DOCKETED
11-AFC-3

To: California Energy Commission
CEC Docket No. 11-AFC-03, Quail Brush Power Generation Siting Case.
Attention: Mark Hamblin and Eric Solorio

Subject: **Additional Photo Survey of Visual Impacts: Mission Trails Day, and Applicant Viewpoint 2 Grasslands Area**

Additional Photo Survey Map of Locations

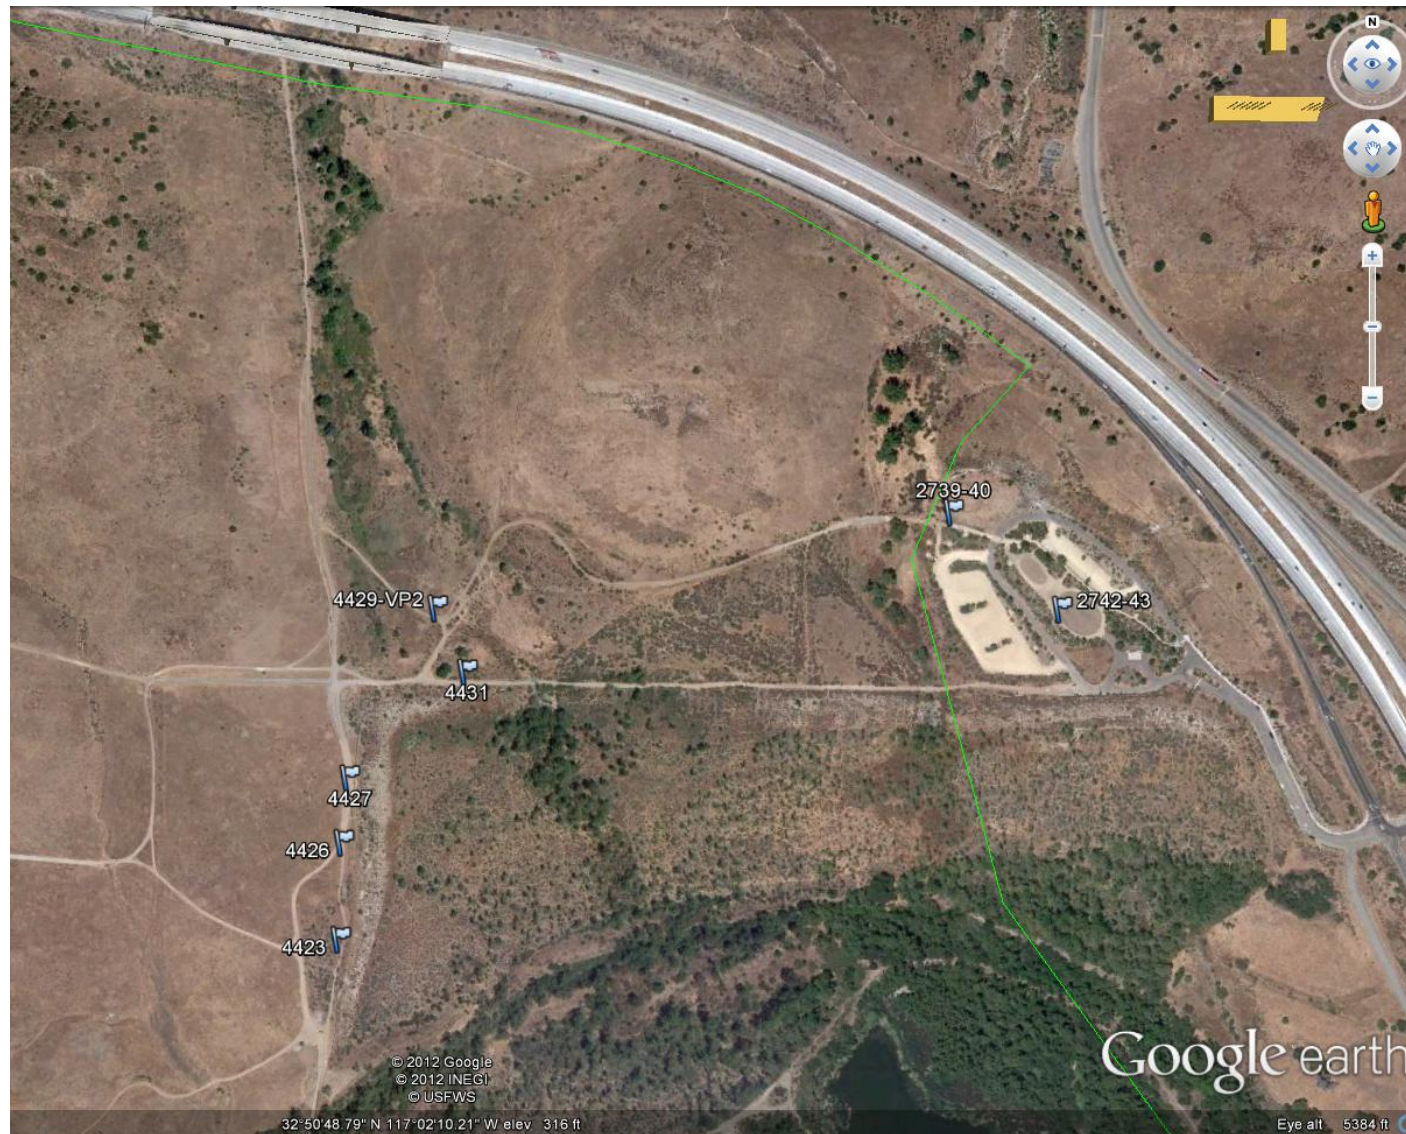
The attached map depicts that the proposed plant would be clearly visible from most of the grasslands area. In contrast, Viewpoint 2 represents a small portion of the grasslands where the power plant would be mostly or entirely blocked by a small hill (and some vegetation), as shown by my attached photo with a simulated power plant. The applicant re-emphasises this point in their response to Sunset Greens HOA Intervenor Data Requests (dated June 12, 2012), where they state that the only area listed as having low visibility is the grasslands section of MTRP due to screened foreground views of the Project from local topography and vegetation. However, in a scientific/technical evaluation, the conclusion is valid only if the input to the evaluation is valid. In this case, the input (the unrepresentative photo) is flawed and therefore the conclusion is flawed.
